**SUPERFUND PROPOSED PLAN FOR
THE ASH LANDFILL
AT THE SENECA ARMY DEPOT ACTIVITY (SEDA)
Romulus, New York**

**Draft-Final Proposed Remedial Action Plan (PRAP) for the Ash Landfill
and the Draft Feasibility Memorandum for Groundwater Remediation Alternatives using
Zero Valence Iron Continuous Reactive Wall at the Ash Landfill
Seneca Army Depot Activity, Romulus, NY**

Draft Final Proposed Remedial Action Plan (PRAP)
Ash Landfill
Seneca Army Depot Activity, Romulus, NY

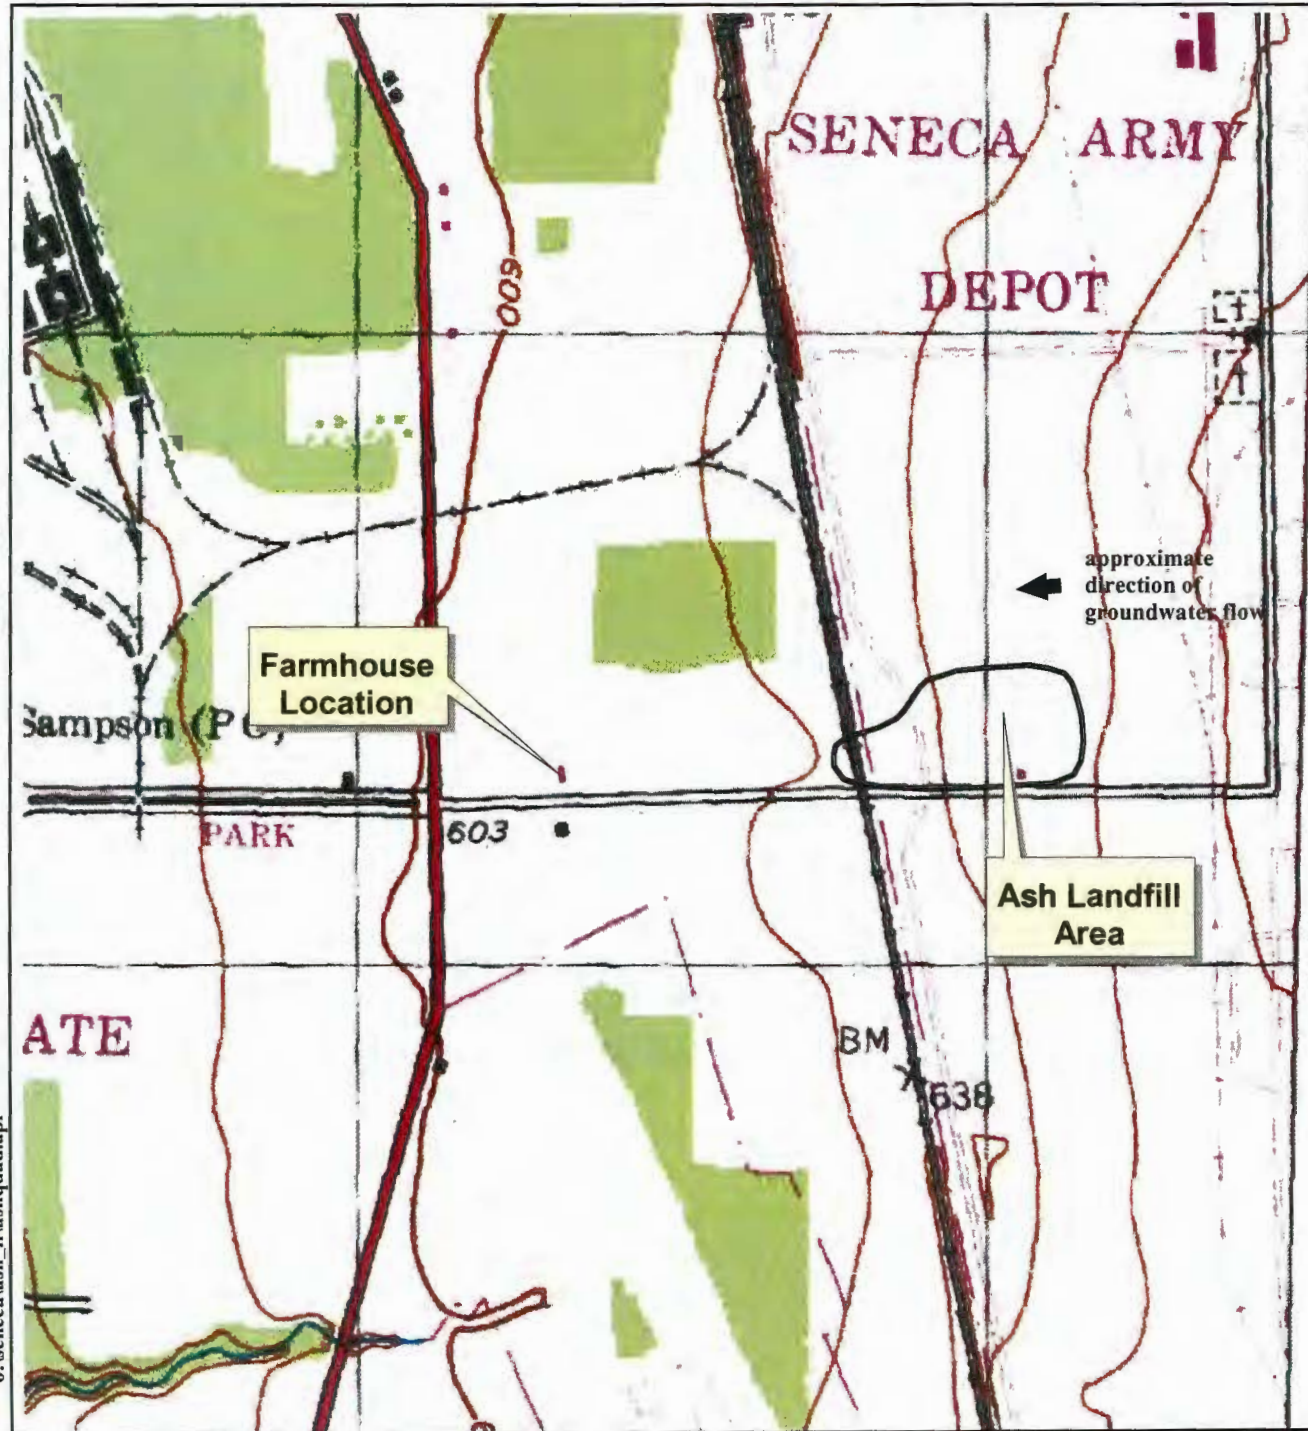
Comment No. 2: As requested in our comment letter of October 9, 1997, "a map, or schematic is required to locate and identify the Ash Landfill, non-Combustible Landfill, groundwater plume and farmhouse". The farmhouse is not depicted in any of the figures in the current Proposed Plan.

Response No. 2: Agreed. The location of the farmhouse relative to the Ash Landfill and the groundwater plume is shown on new Figure 3. Figures 3 through 5 have been renamed as Figures 4 through 6.
